MEMORANDUM

FILE NO.: VAR2012 0023

PROPOSAL: A variance to reduce the front yard setback from 11 feet to 5 feet in order to construct a 2nd story entry deck.

Property Address: 209 Saint Ann's Avenue

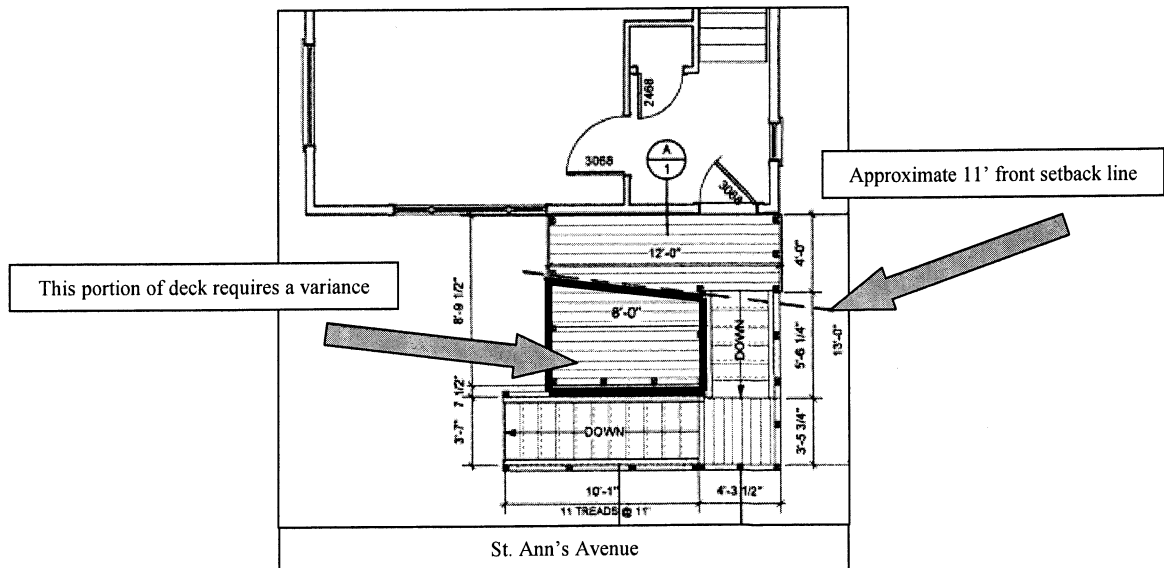
Both primary access and emergency egress would be adequately provided by an entry deck that meets the exception provided for in CBJ49.25.430(4)(C)(i). As the above sketch shows, an adequate stairway and smaller deck are allowed without a variance. Additionally, the main living area is provided with a large exterior deck at the rear of the second floor and an entrance off that deck that leads directly into the kitchen.

A DECK FRAMING
Scale: 1/2" = 1'-0"

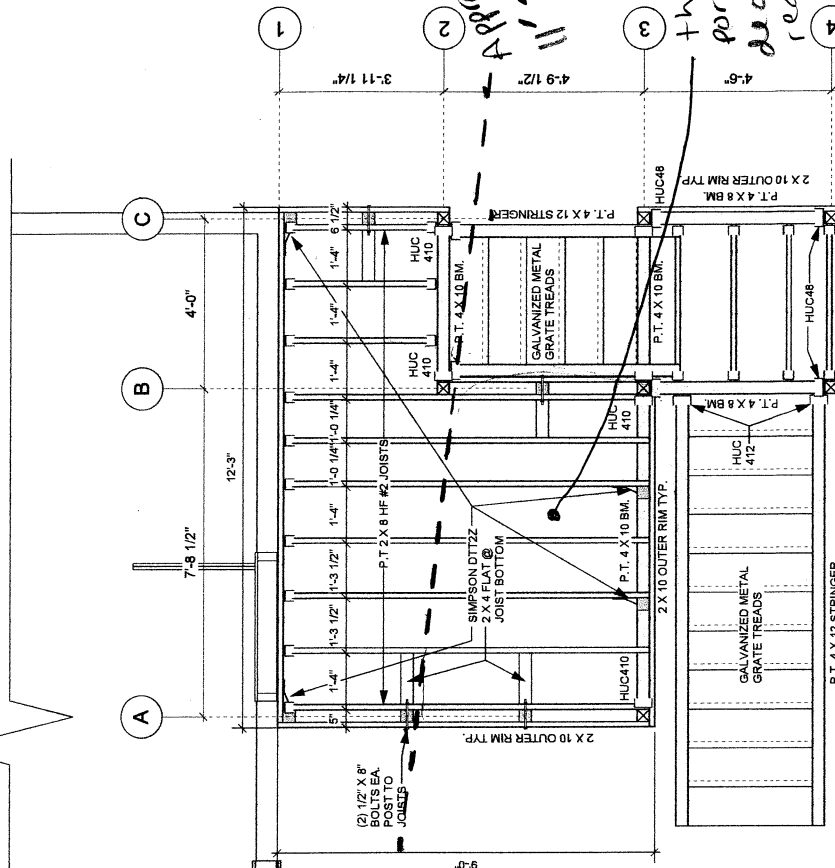
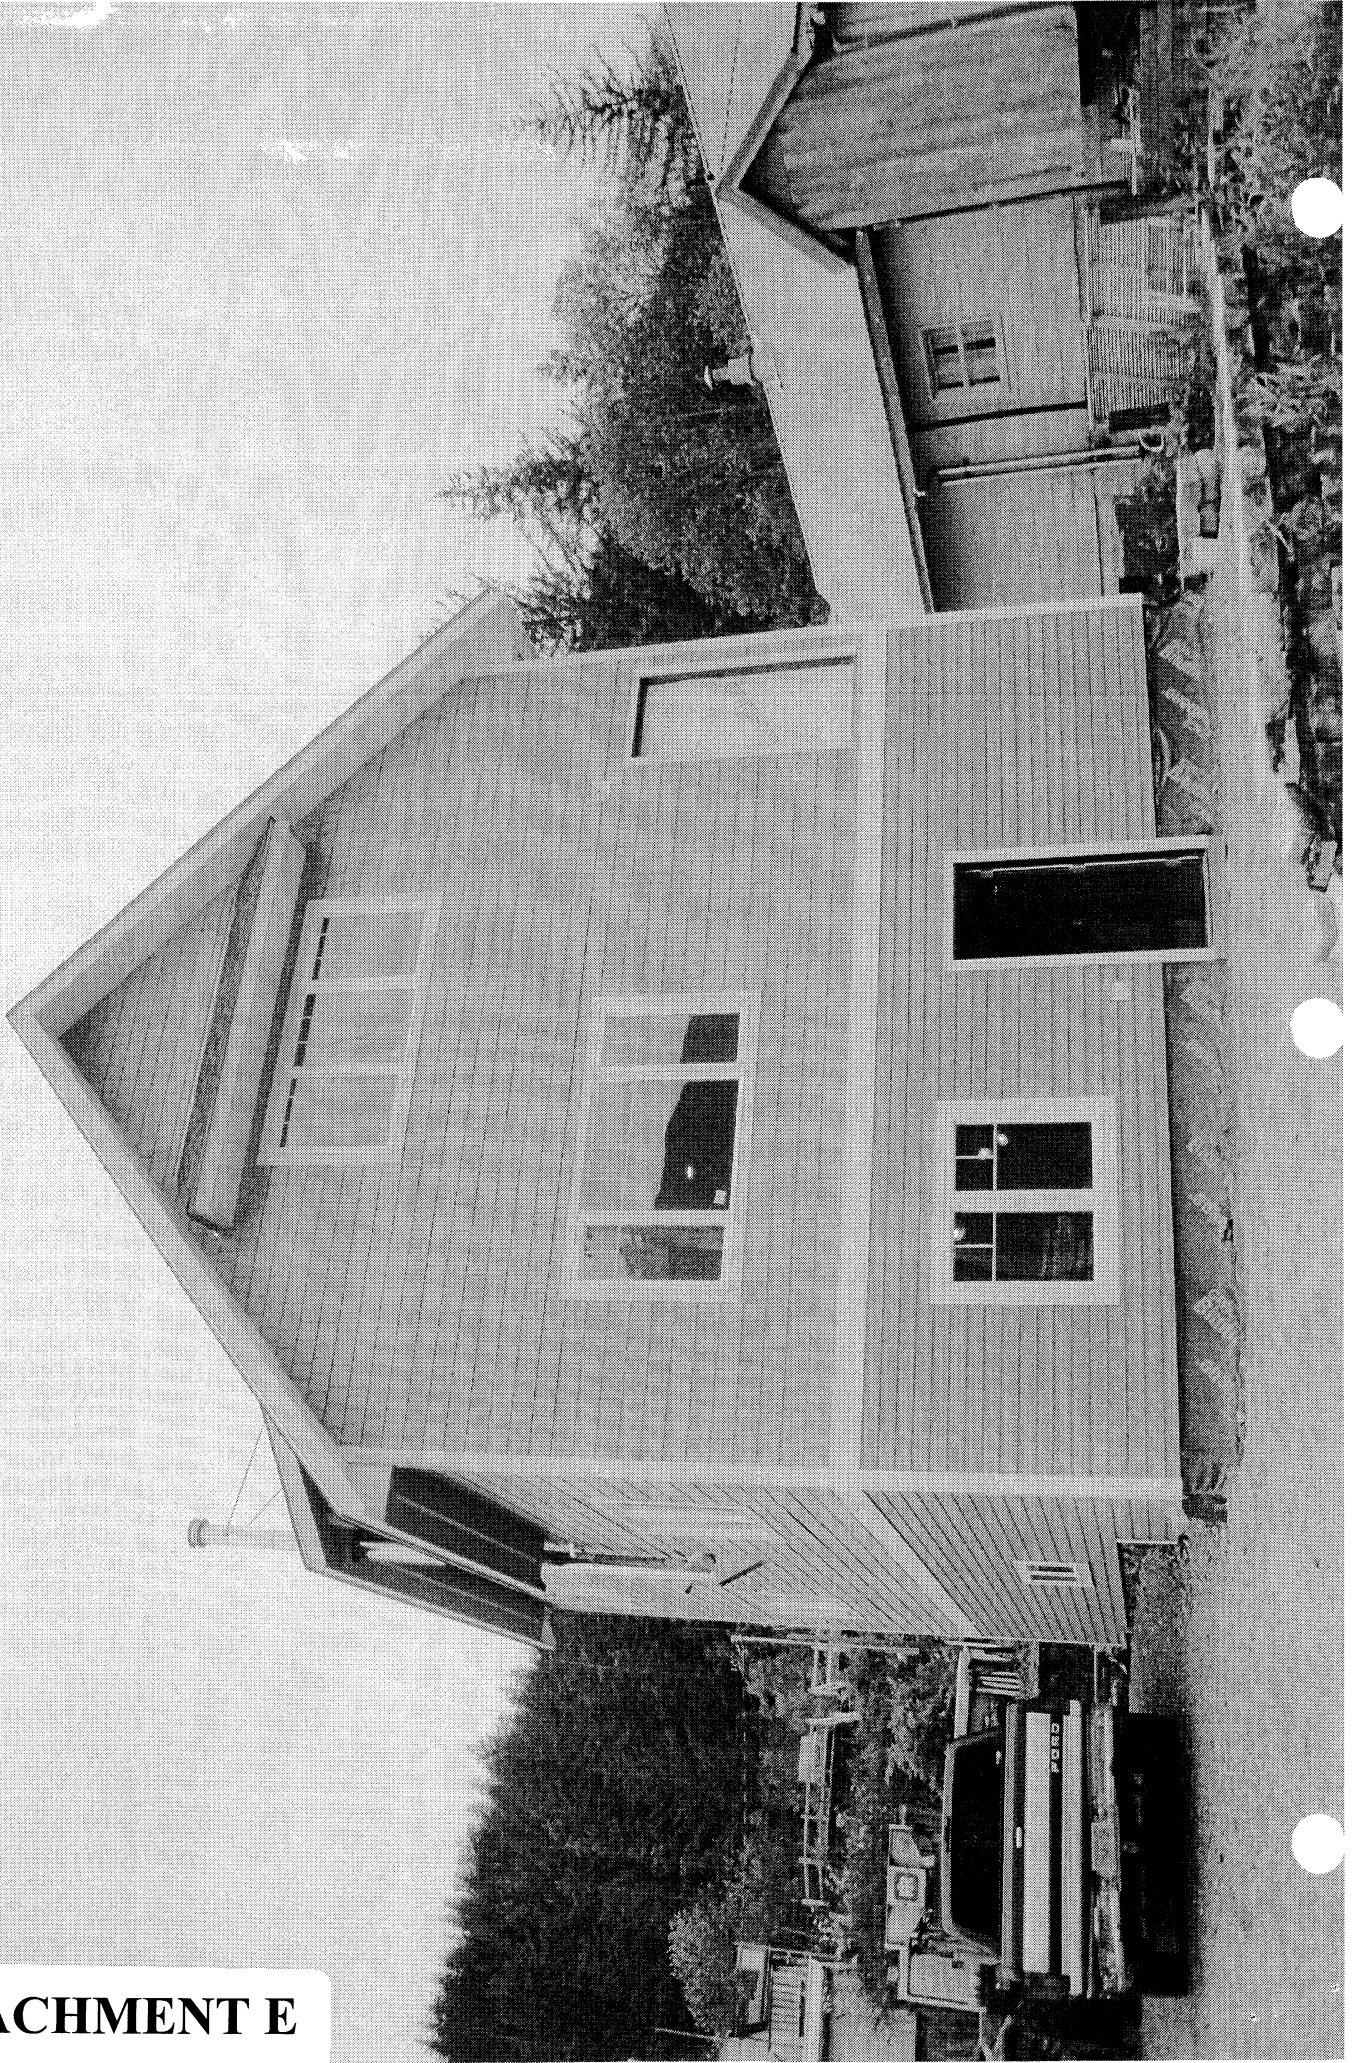
The applicant is requesting a variance to reduce the front yard setback from 11 feet to 2 feet in order to construct a 2nd story deck and stairs on a new single-family home. However, the stairs meet exception CBJ49.25.430(4)(C)(i), and a portion of the deck is behind the front setback line. The portion of the deck that does require the variance is located at approximately 5 feet from the property line. The subject site has a reduced front setback from 20 feet to 11 feet due to an average of the existing substandard setbacks in the neighborhood.

The second story of the new home is accessed by the proposed stairs and deck. The proposed access consists of a main L-shaped deck, and two sections of stairs with a landing in between. The landing and stairs are no greater than five feet in width, and meet the setback exception provided by CBJ49.25.430(4)(C)(i), which allows entry decks and stairs no wider than 5 feet internal width to be located up to the front property line. Approximately 4 feet of the depth of this deck is outside of the 11-foot setback and is also allowed without a variance. The portion of the deck that actually requires a variance is approximately 7 feet, 8 inches wide and approximately 5 feet deep, and is located approximately 5 feet from the front property line. The drawing below shows the portion of the deck that is behind the 11-foot front setback and the portion which requires the variance.

If the portion of deck requiring a variance were reduced from 7 feet, 8 inches in width to 5 feet, it would not require a variance. The applicant has stated that a smaller deck could not be constructed without the supporting posts being located in such a manner that the basement door access is impeded. However, no information has been submitted showing that various cantilever or alternative structural designs cannot work.

this portion of deck requires variance

Height of walls determining
First Story Status

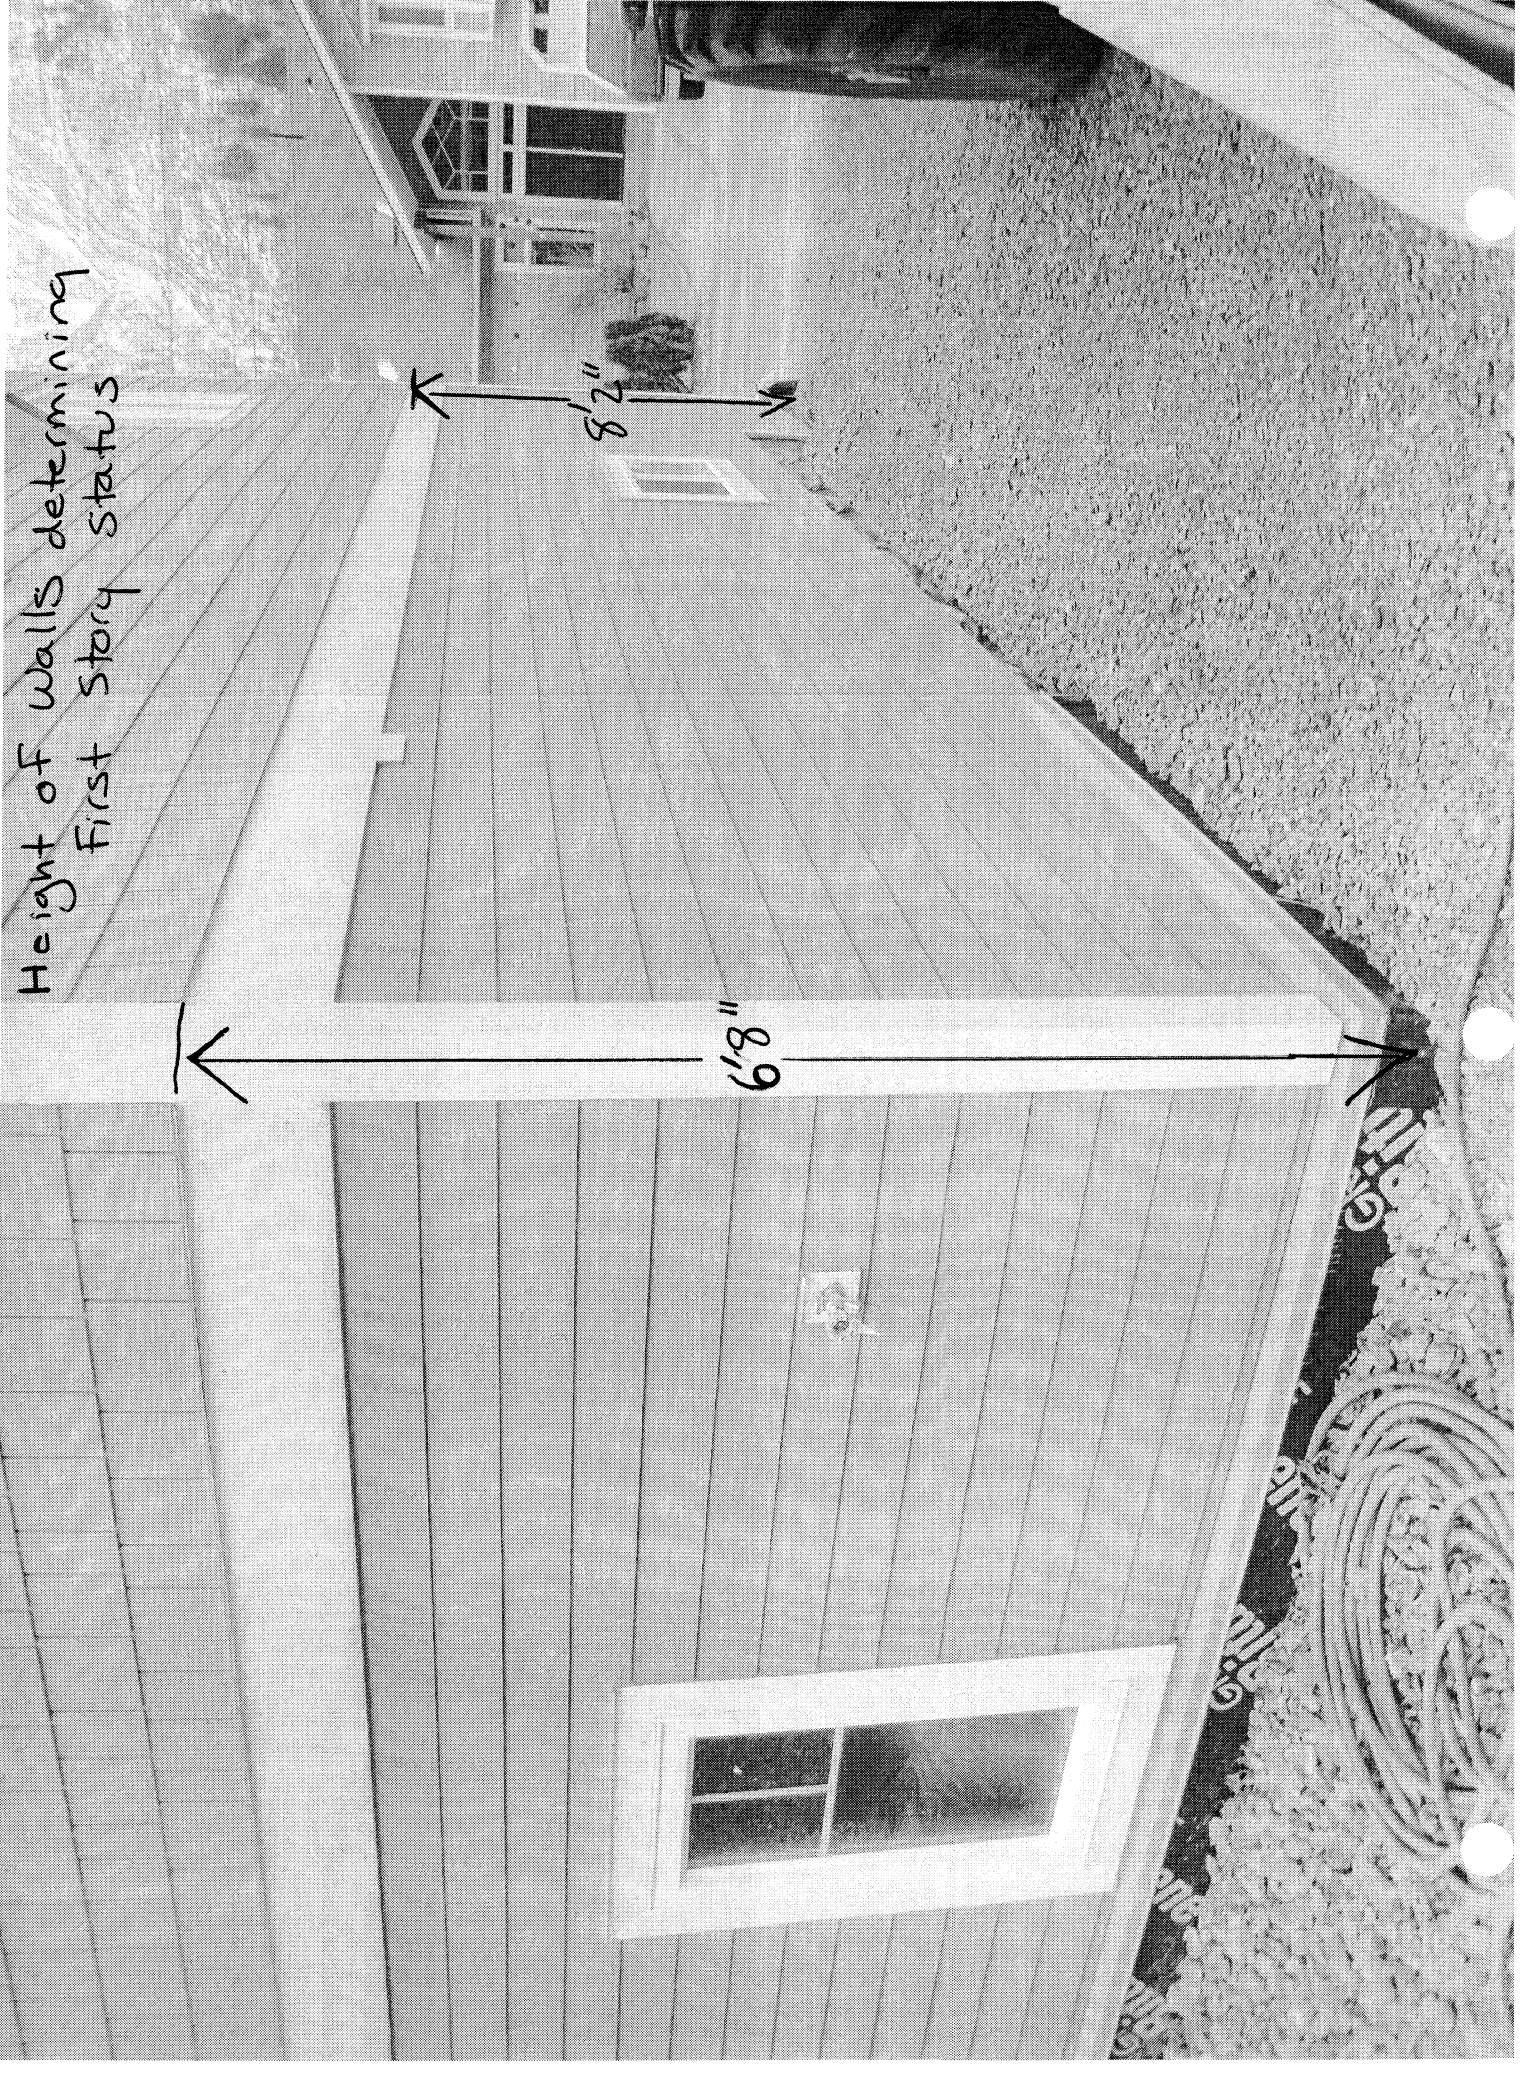
In this case, the finished surface of the floor above the ground floor is more than 6 feet above the finished ground level for 100% of the total building perimeter, and therefore the "basement" is actually by definition a first story, and therefore the proposed front deck is a second story deck. The
